SERVICE PARTS LIST FOR MITSUBISHI ELECTRIC PACKAGED AIR-CONDITIONERS

Series : PEFY-P•VMHS-E-F

REVISED

BWE01805C

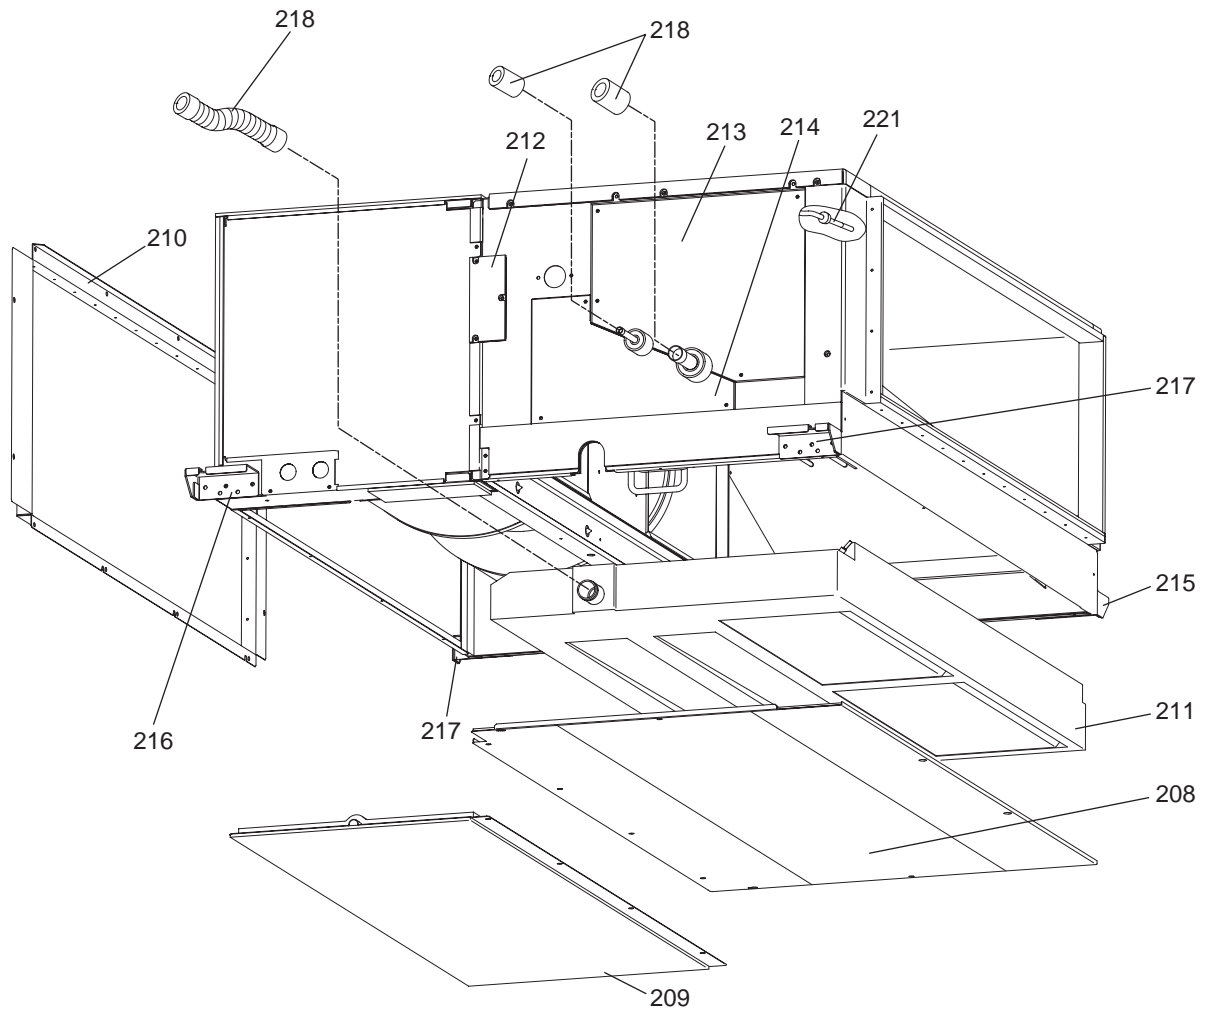
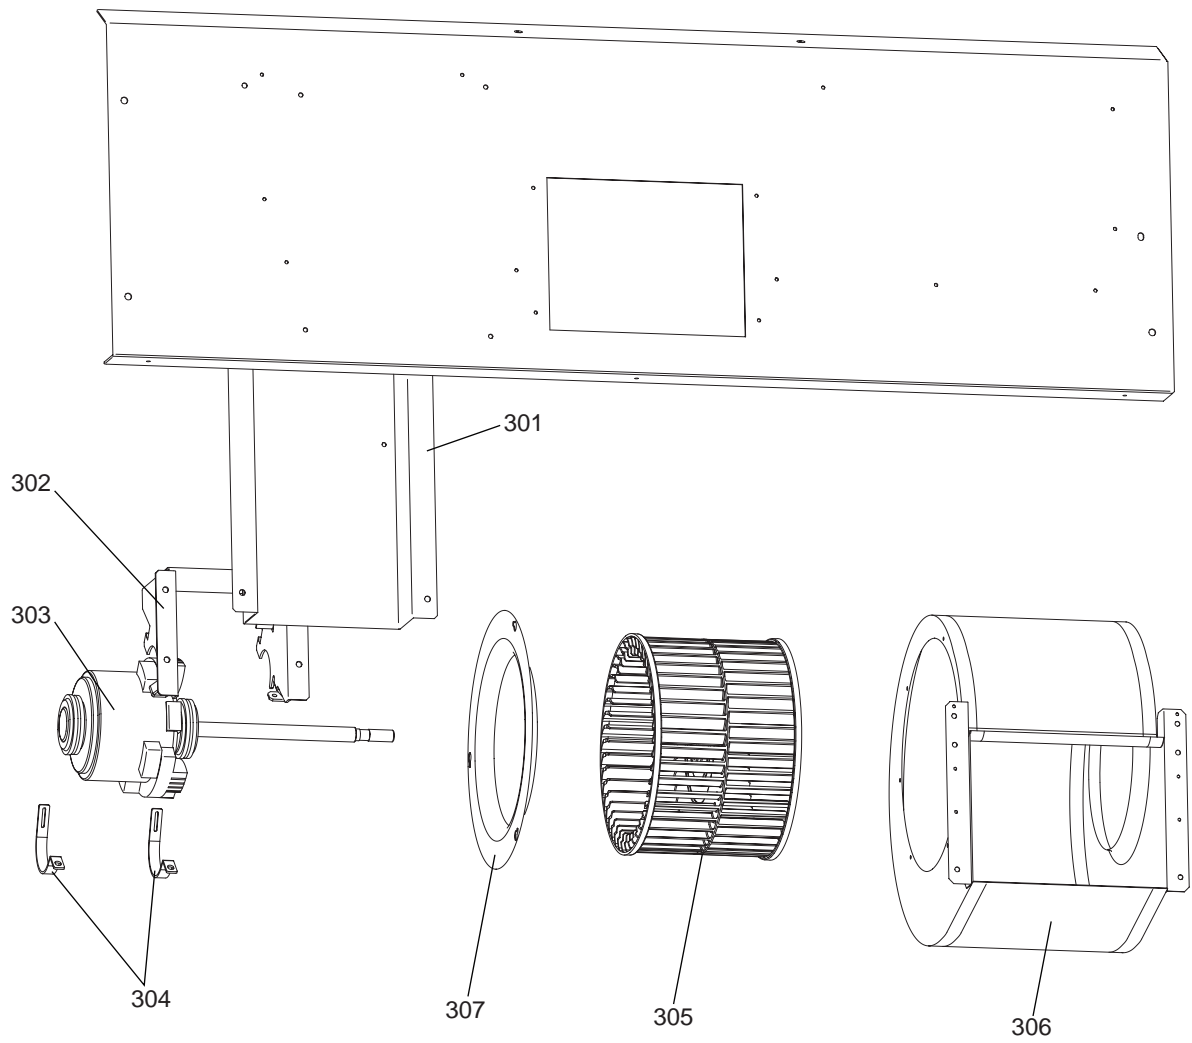
Please change the old catalog (issued Aug. 2019, No.BWE01805B) to this new catalog.
Content of revision : Some of parts are changed.

*1 Products manufactured to Sep. 2019 use EFM type LEV, and products after Oct. 2019 use PAM type LEV. In case of EFM type LEV is used, please change to PAM type LEV. In that case, replace it with a set of 103 and 116. Please order 117 when replacing only the motor part with EFM type.

Grounding wire
(The grounding wire is provided only for units with the serial numbers 9ZW***** or later.)

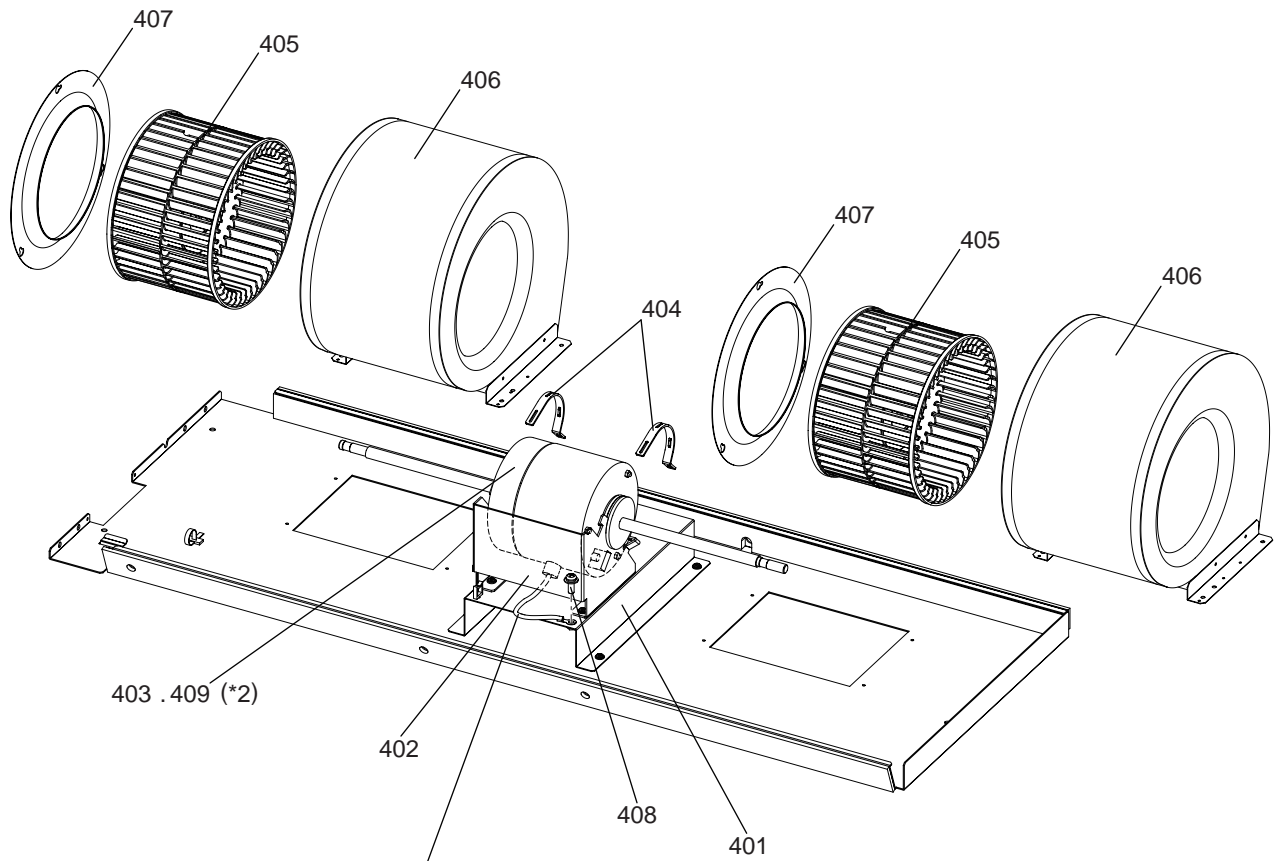
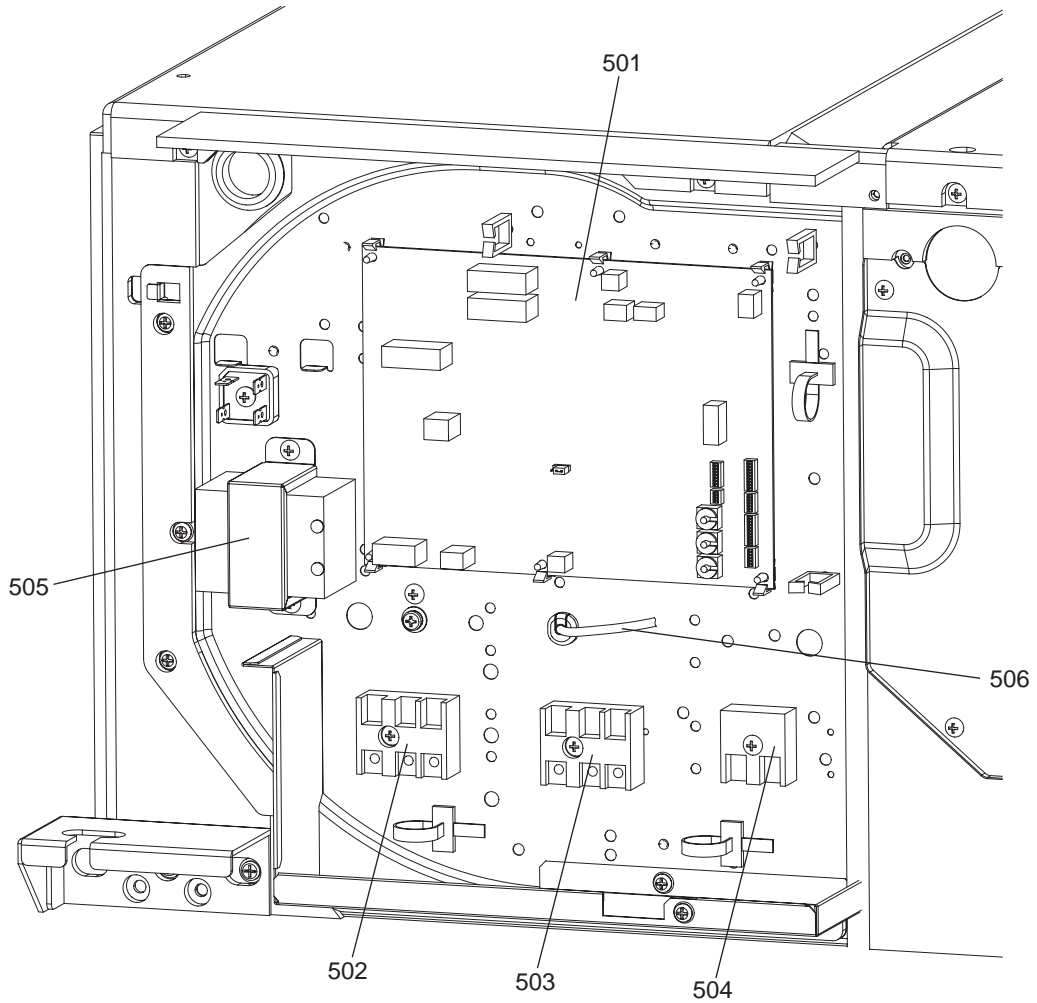
*2 Units with the serial numbers 9YW***** or earlier do not have the grounding wire.
When replacing the motor on the unit that has no grounding wire, prepare 409, not 403.
To check whether the unit has the grounding wire or not, see the part indicated as "MF" on the wiring diagram plate.
